Meeting: Strategic Planning Committee

Date: Tuesday 22 June 2021

6 **20/06775/WCM: Northacre Energy from Waste Facility, Stephenson Road, Northacre Industrial Estate, Westbury, BA13 4WD** *(Pages 3 - 74)*

Northacre Renewable Energy Limited**Northacre Facility**Response to Odour Assessment review and further Odour Modelling

Figure 1 - Vent and receptor locations

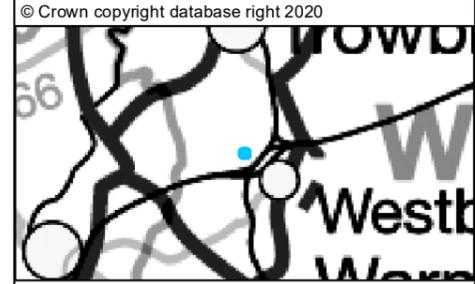
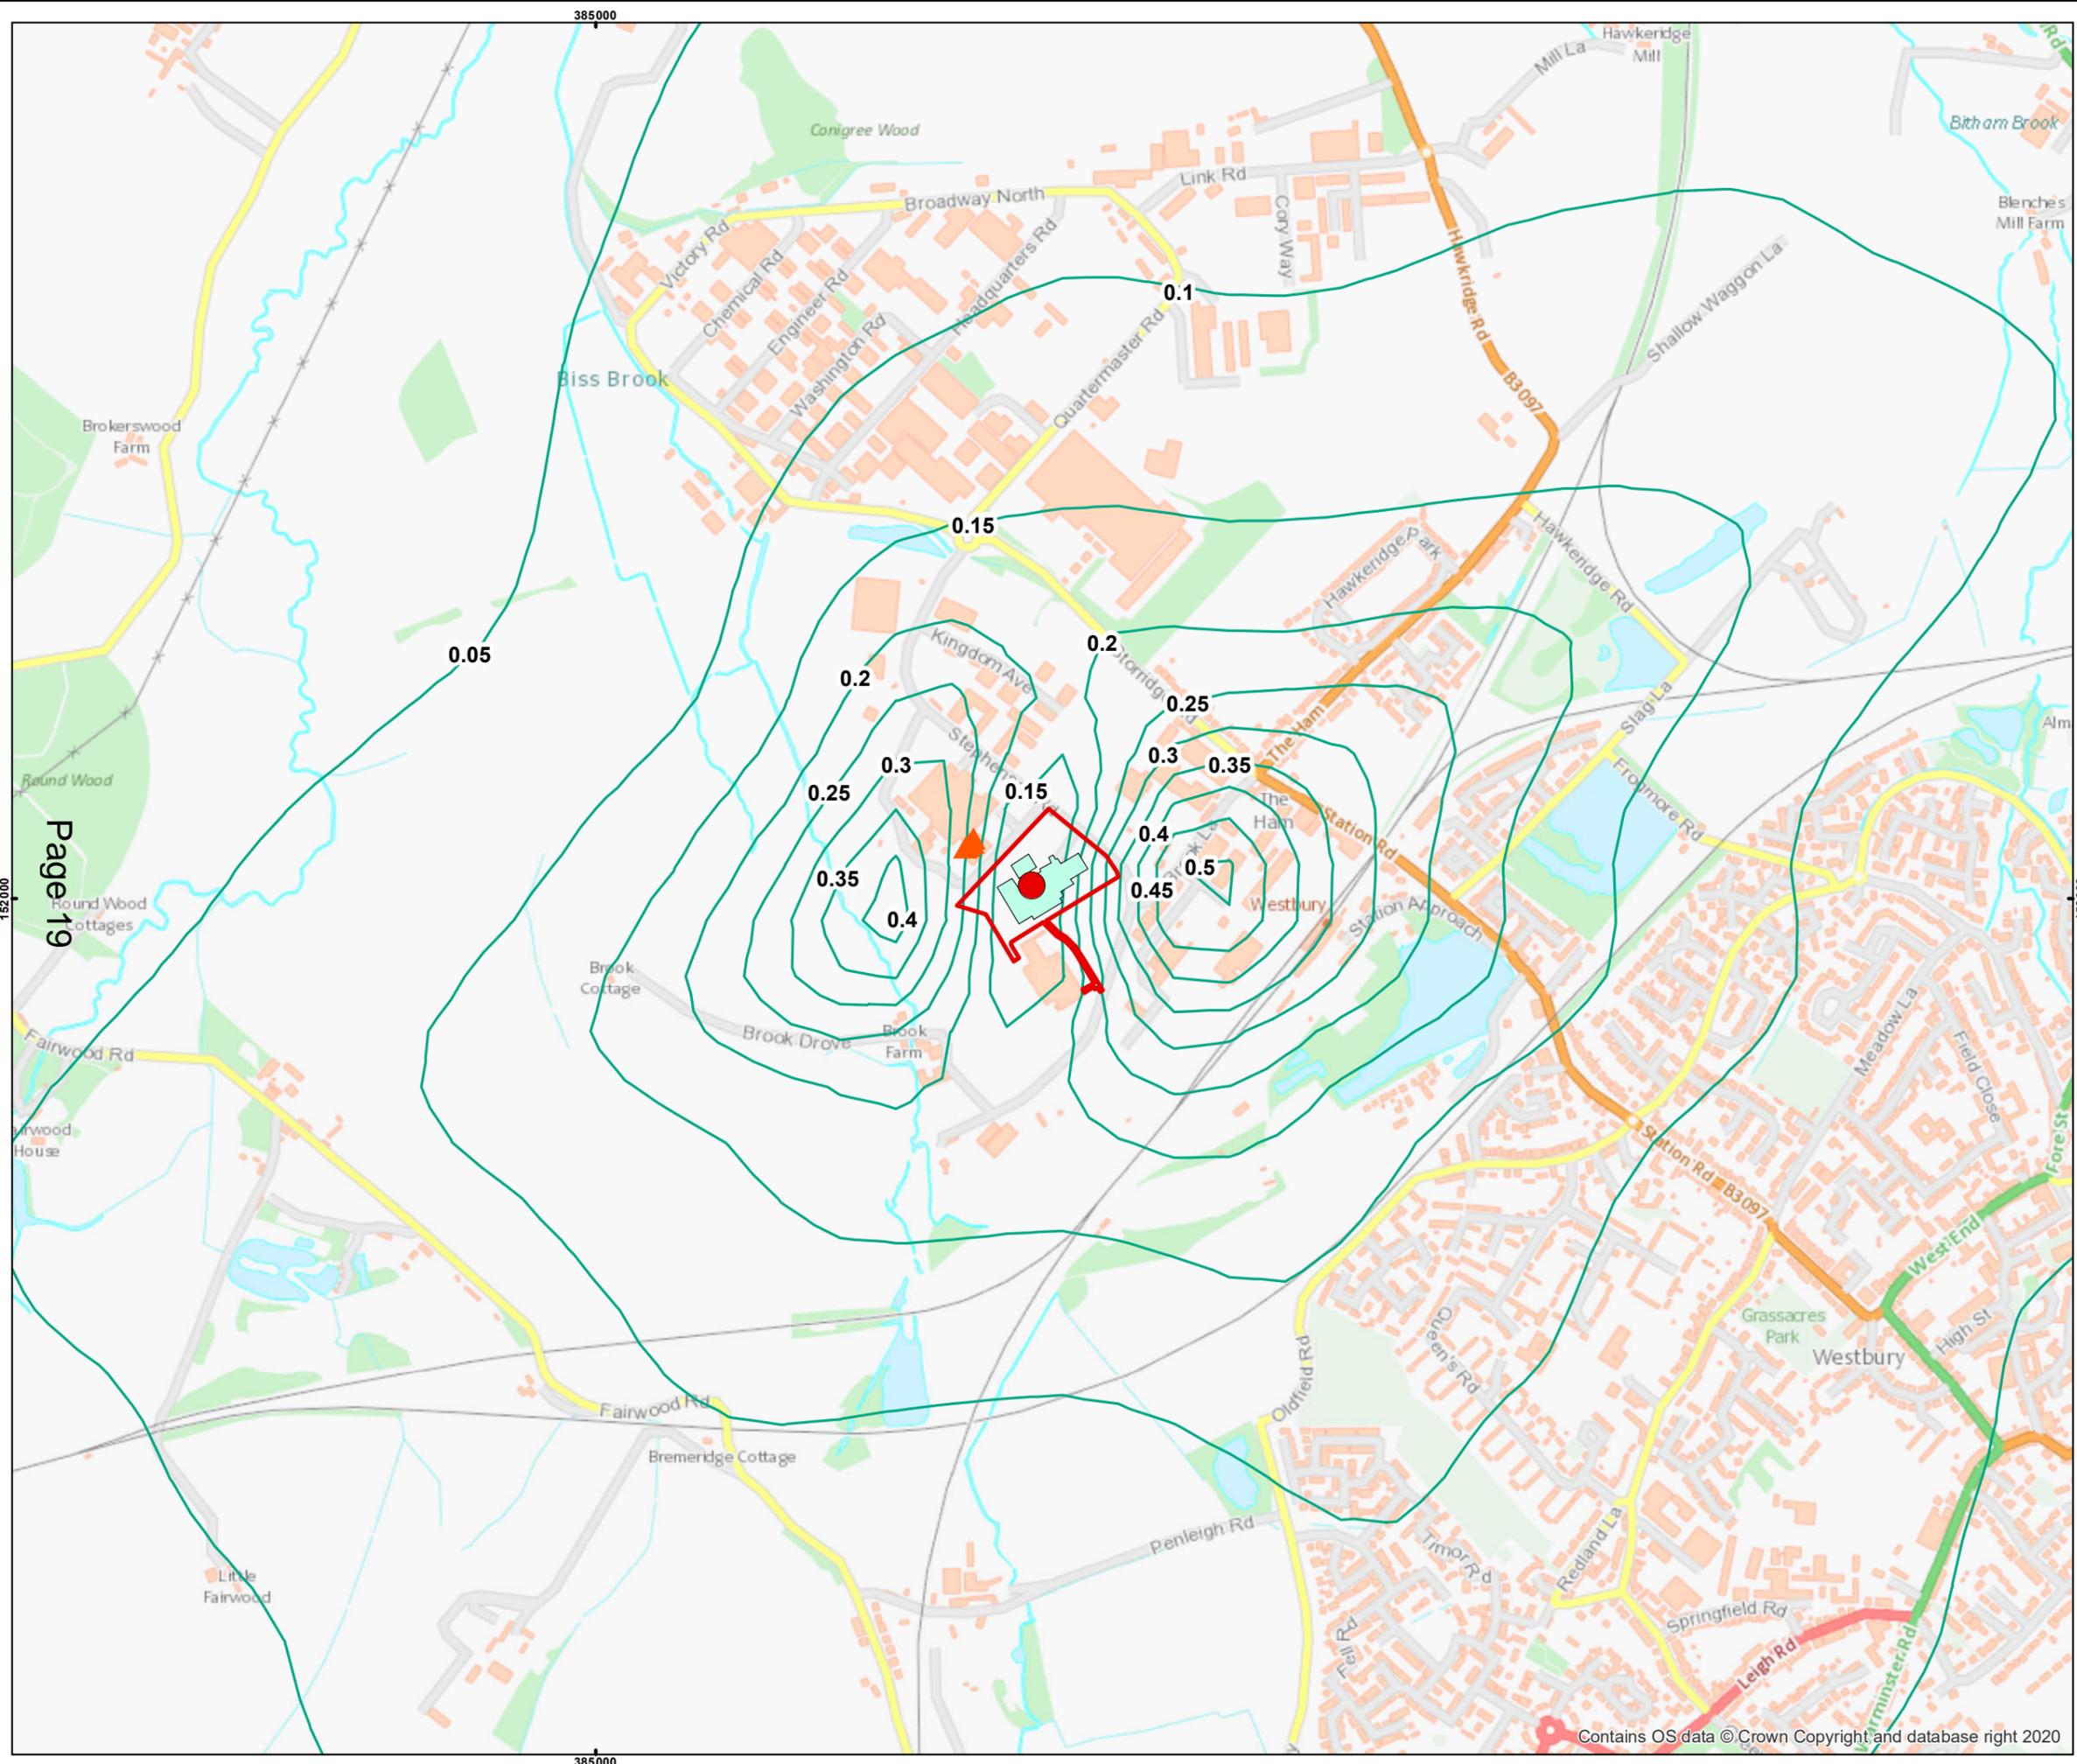
“In Table 8.18, the risk of odour exposure at Westbury Dairies (receptor OR13) has been classified as 'low' risk. However, using the Institute of Air Quality Management (IAQM) methodology, if the source odour potential is 'large' and the pathway effectiveness 'highly effective', the risk is classified as 'high'. In turn, the likely magnitude of odour effect at a receptor of 'high' sensitivity is 'substantial adverse', which would be considered 'significant'.”

“Notwithstanding the above, we would also request that a quantitative assessment of impacts associated with odour and bioaerosol emissions from the odour abatement plant is undertaken. This should consider impacts during planned and emergency events, as well as site commissioning, and analyse normal operation of the odour abatement plant and any periods when this may not be functional. Experience of similar facilities has indicated significant emissions during certain events and it is essential to ensure these do not cause adverse impacts at Westbury Dairies.”

The calculated capture distance value of 7.79 m has been rounded up to 8 m for the purpose of this assessment. To ensure the entire potential area of influence from the vents is covered, 5 receptors have been modelled at 3 different heights; ground level, 5 m (the height of the vents), and 13 m (the height of the vents plus 8 m potential air capture distance). This is the same approach that was used by the planning application for the MBT plant, with updated vent dimensions and intake rates. The receptors are listed in Table 2 below and included on Figure 1.

Receptor	Elevations (m above ground level)	X (m)	Y (m)
R1	0,5,13	385609	152092
R2	0,5,13	385598	152084

Receptor	Elevations (m above ground level)	X (m)	Y (m)
R3	0,5,13	385611	152098
R4	0,5,13	385605	152090
R5	0,5,13	385603	152086
